Committee of the Whole Report For the Meeting of May 26, 2022

To: Committee of the Whole **Date:** May 13, 2022
From: Karen Hoese, Director, Sustainable Planning and Community Development
Subject: Development Permit with Variances Application No. 00051 for 937 View Street

That Council decline Development Permit with Variances Application No. 00051 for the property located at 937 View Street.

1 Shadow Study - Equinoxes - 10AM
A105 SCALE: 1 : 1000

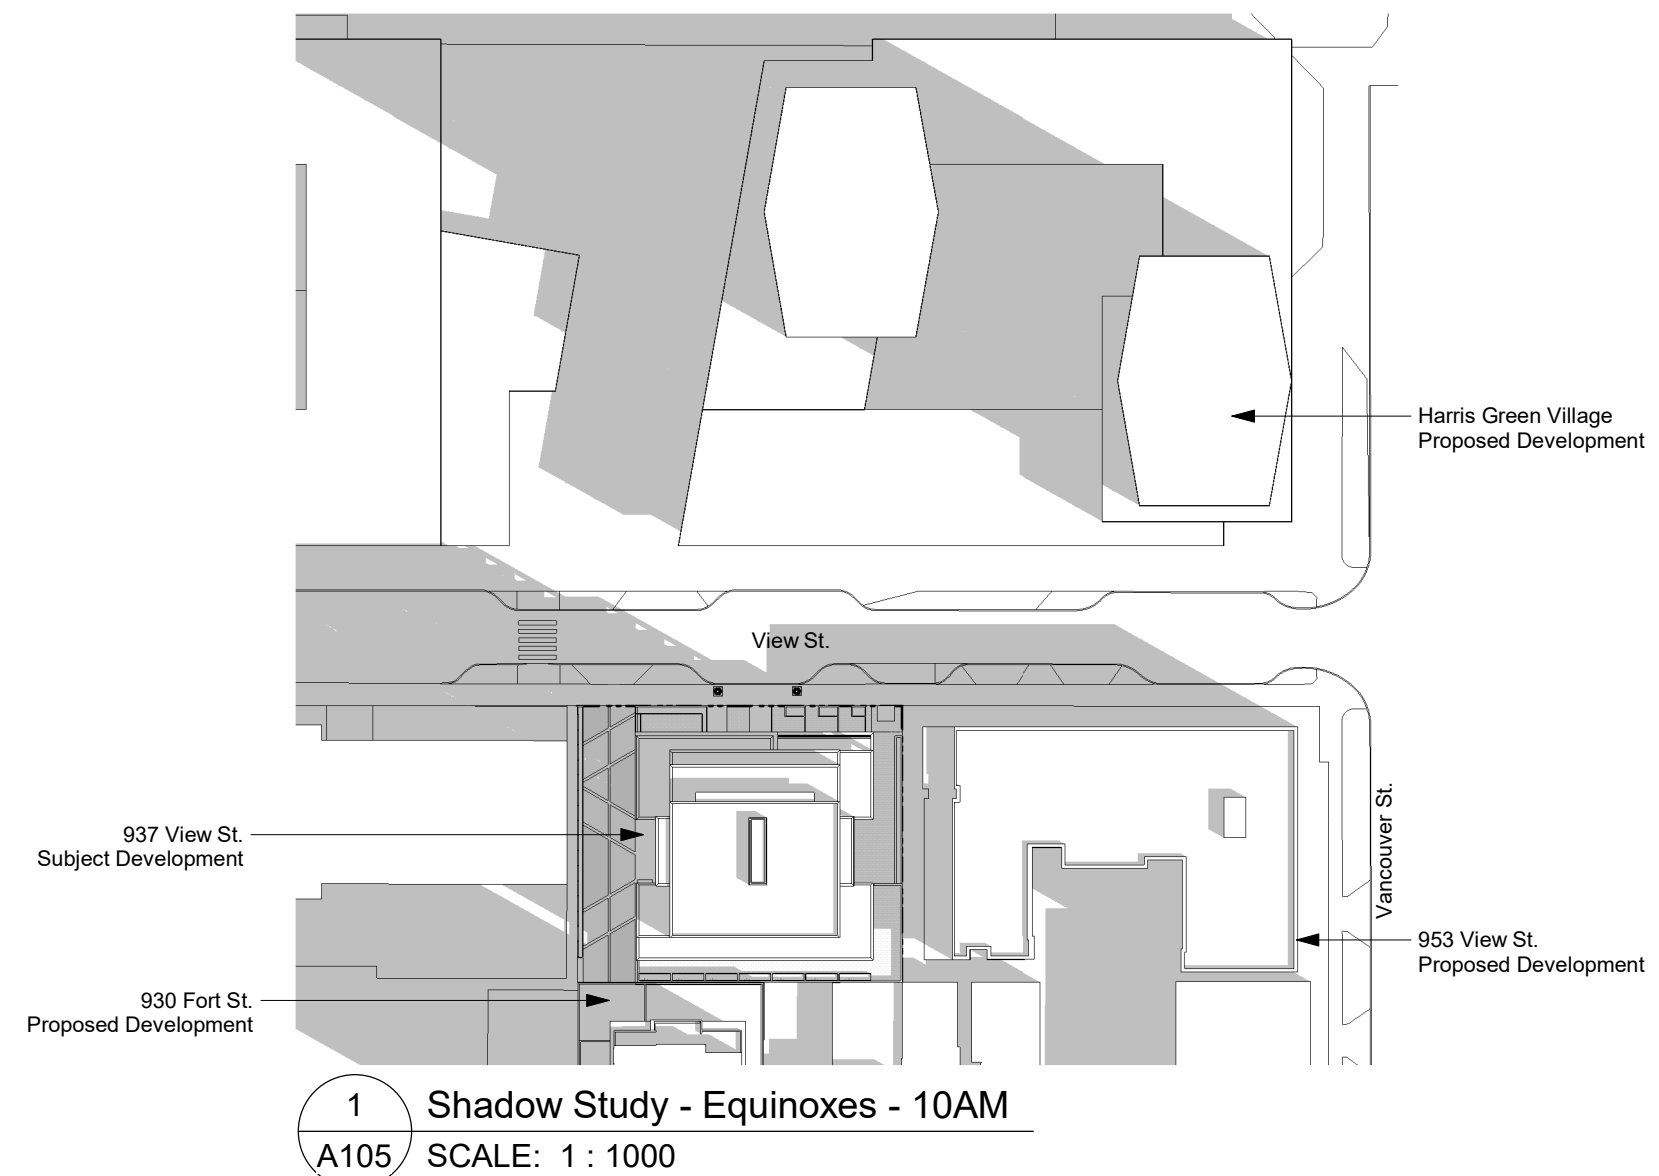
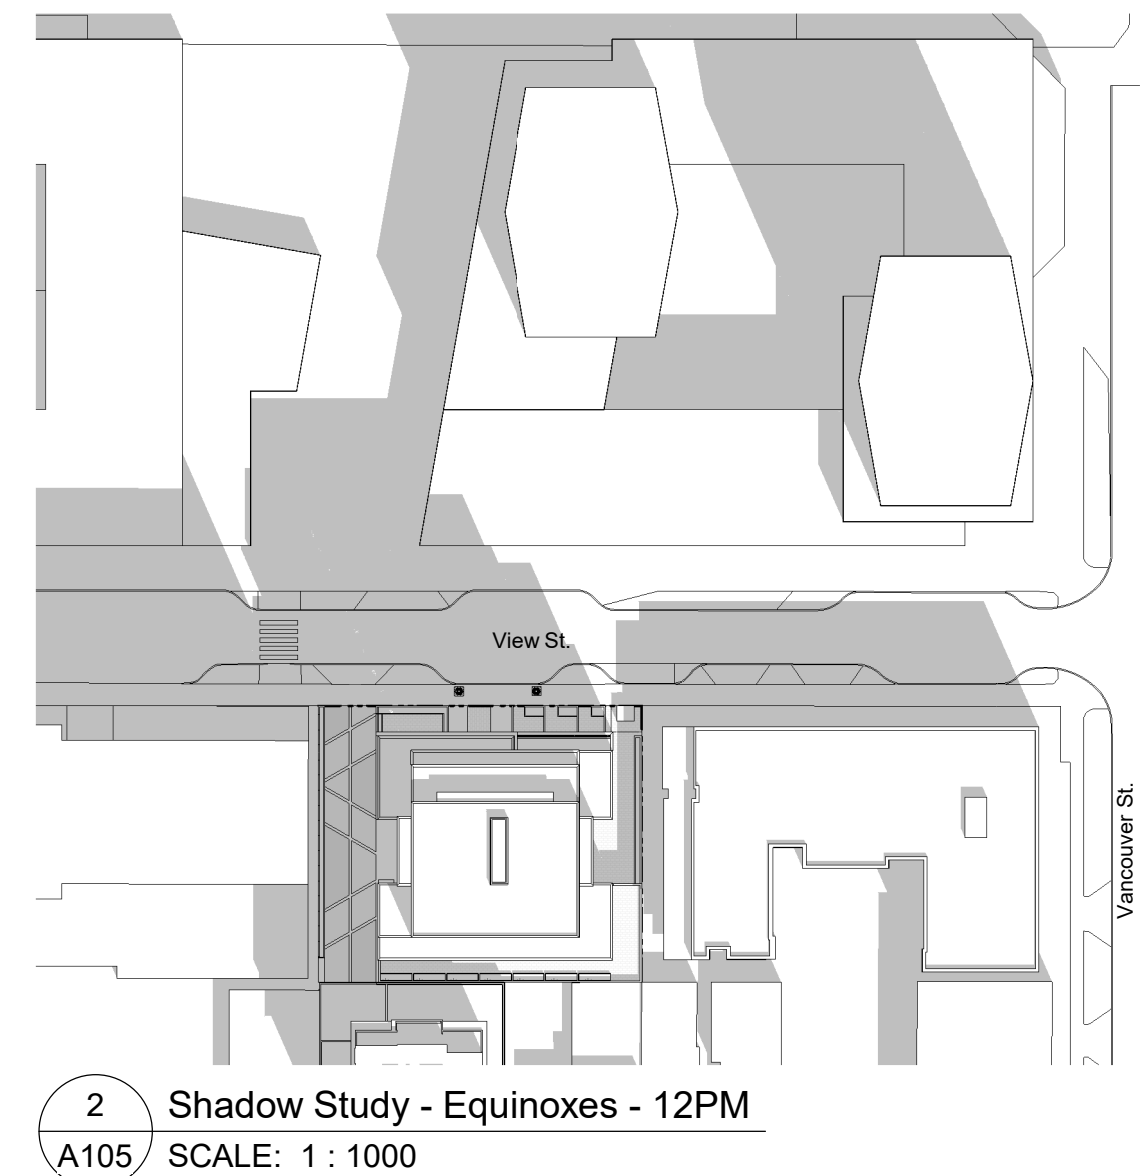
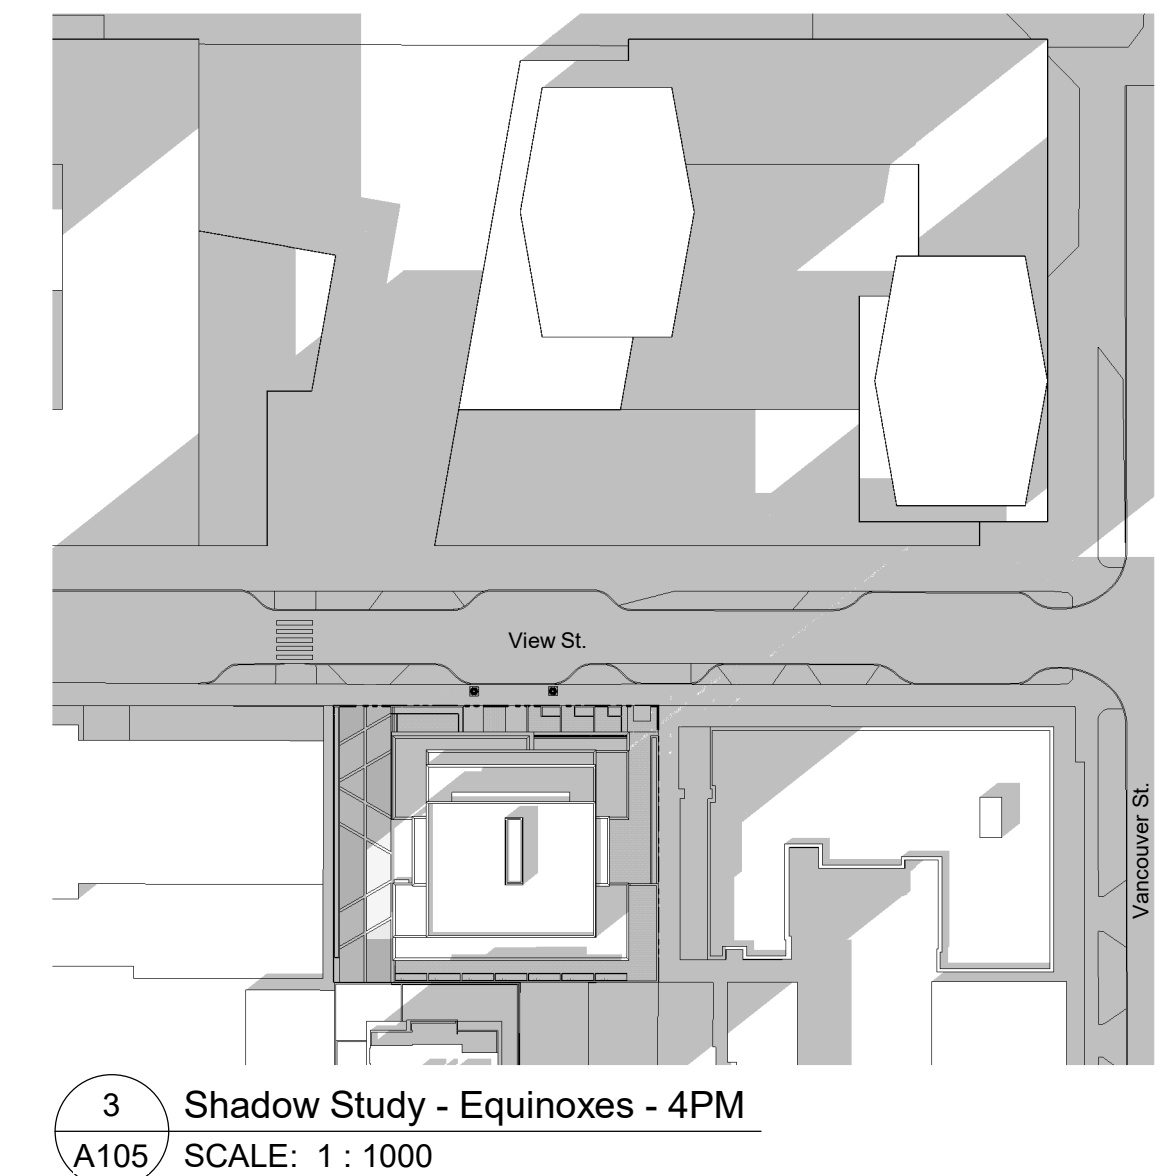
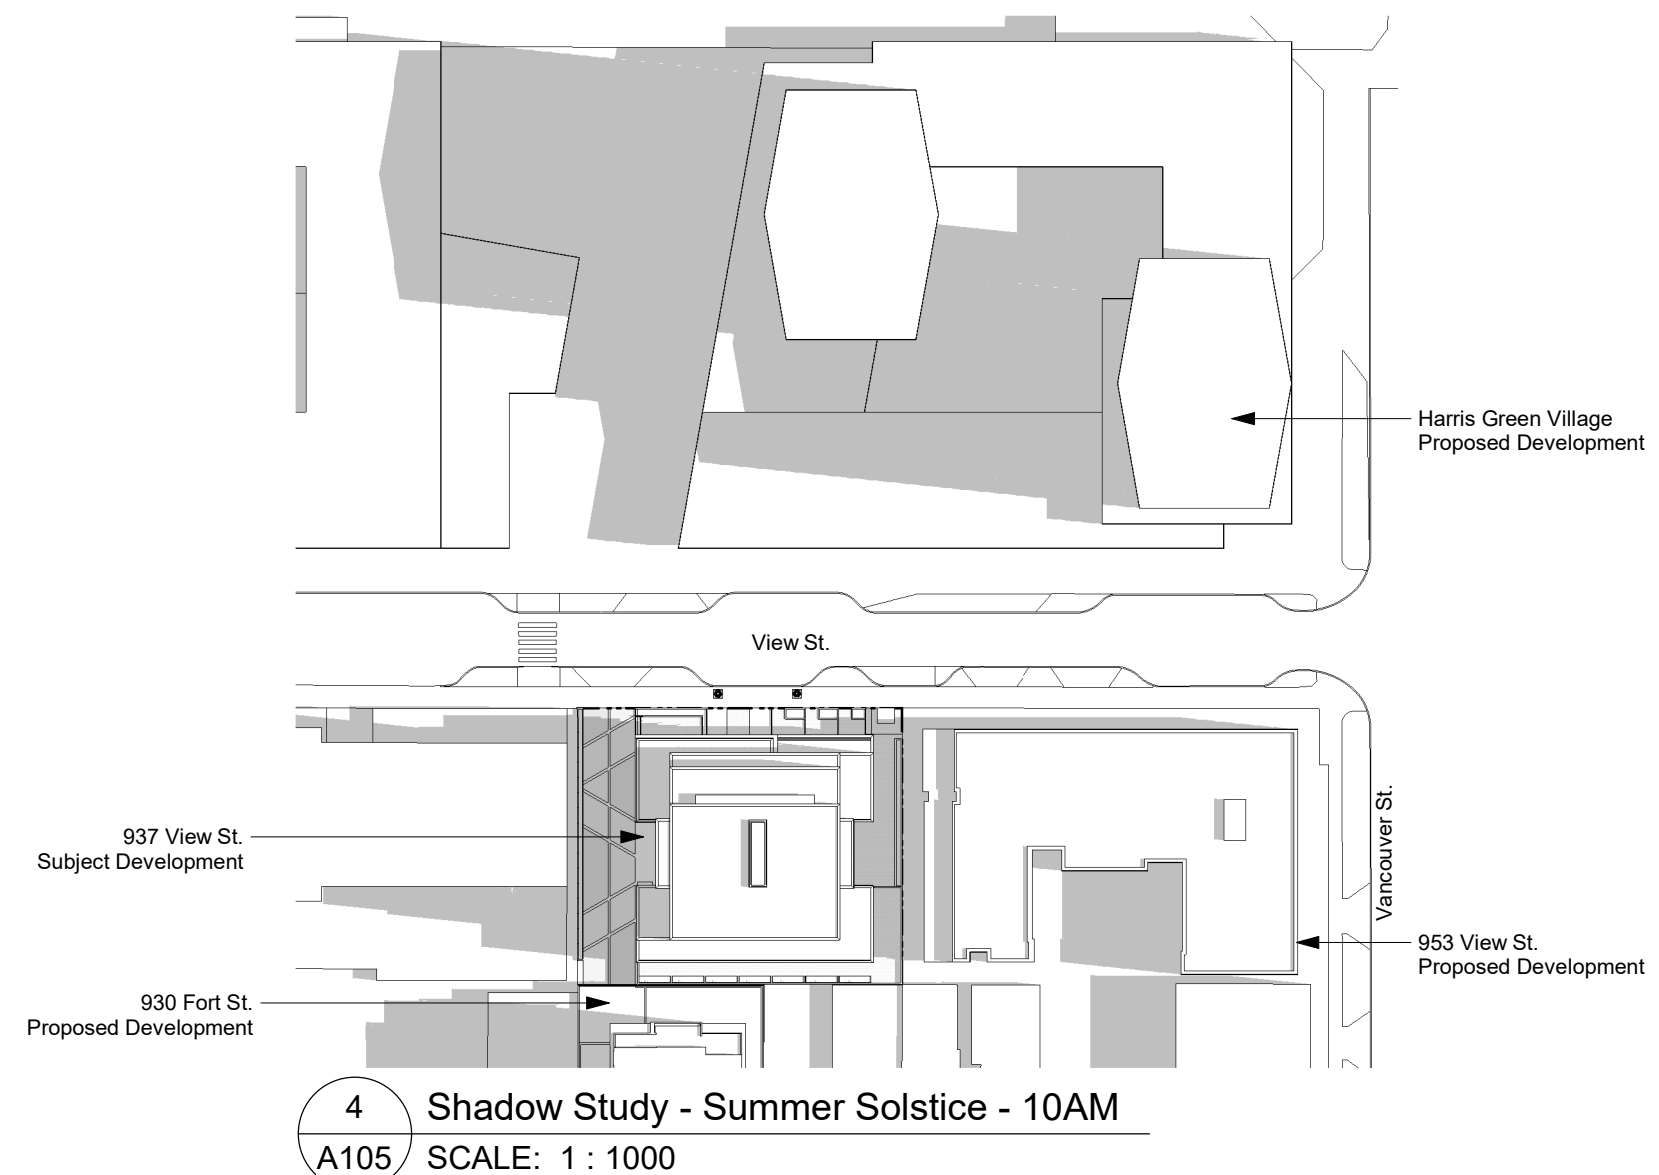
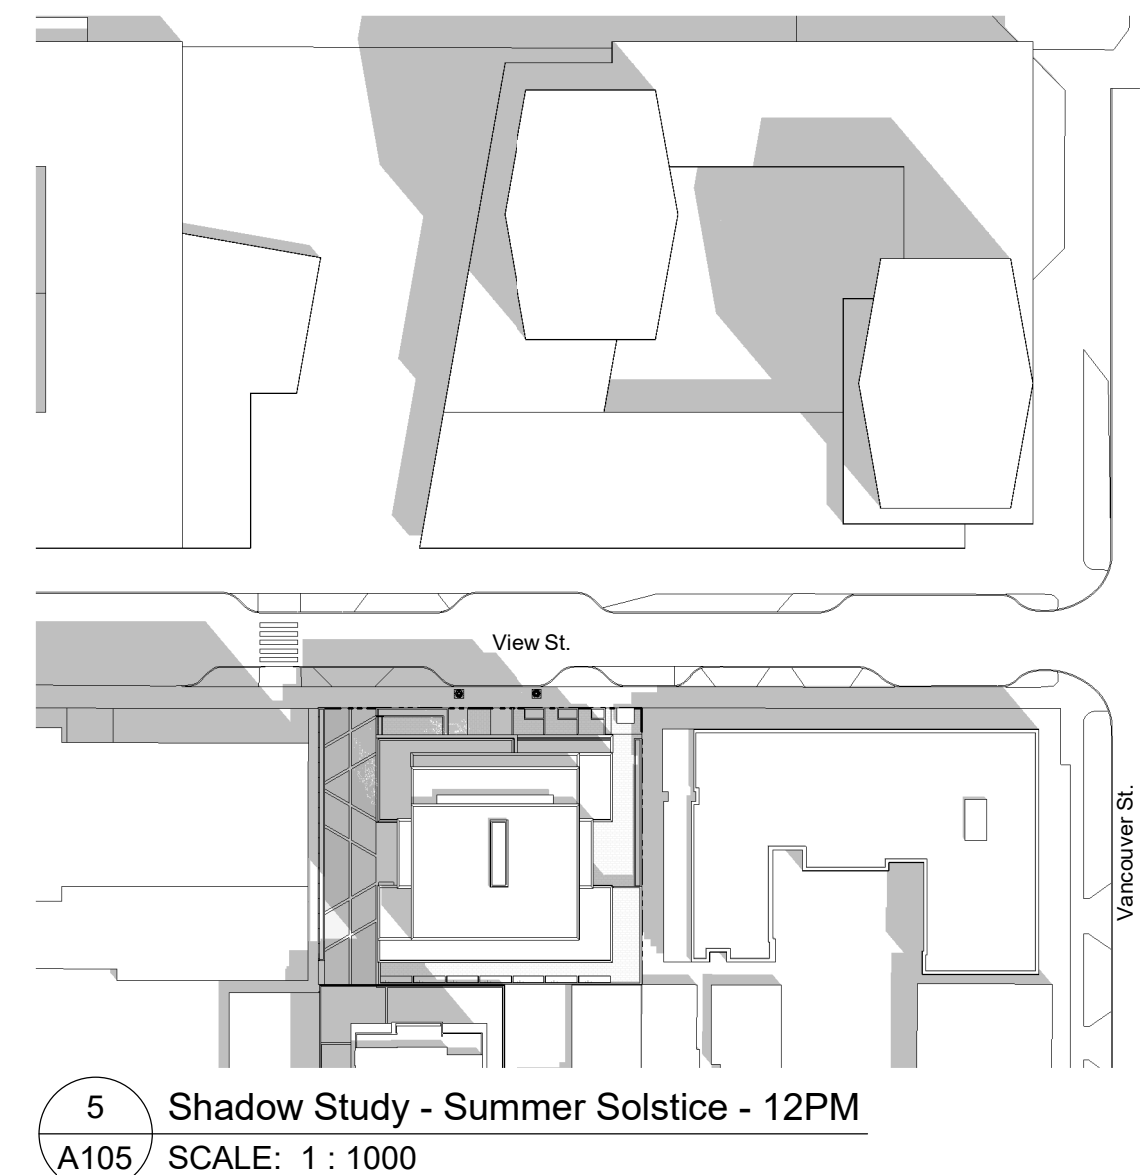
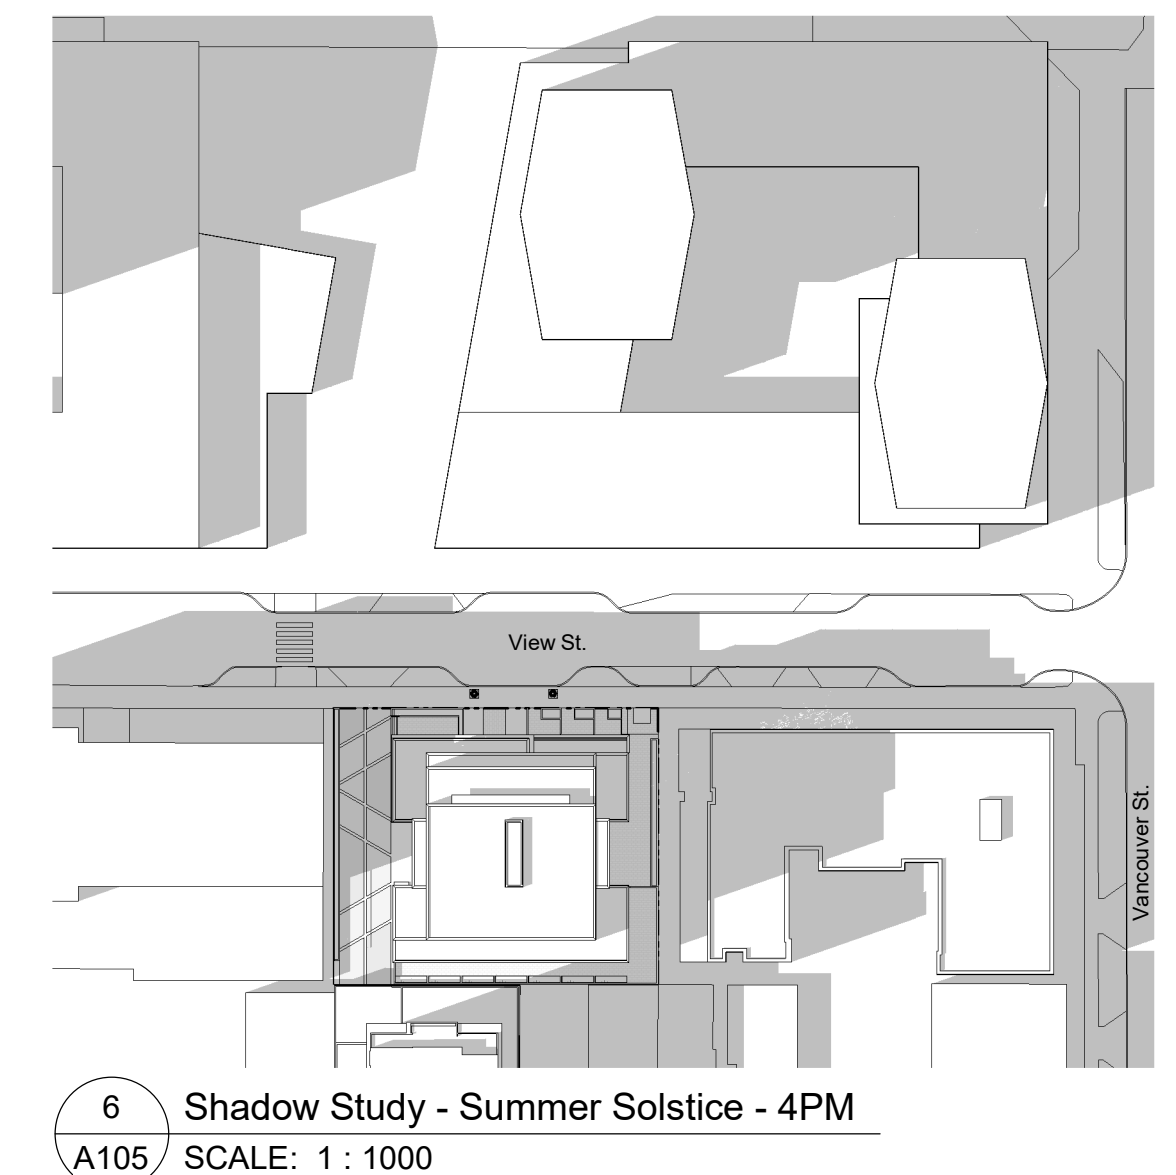
- The impact of the proposed height variance would have a detrimental impact on shading of the public realm, access to sunlight and views to the open sky, and the location directly adjacent to an existing tall building would exacerbate these negative impacts.
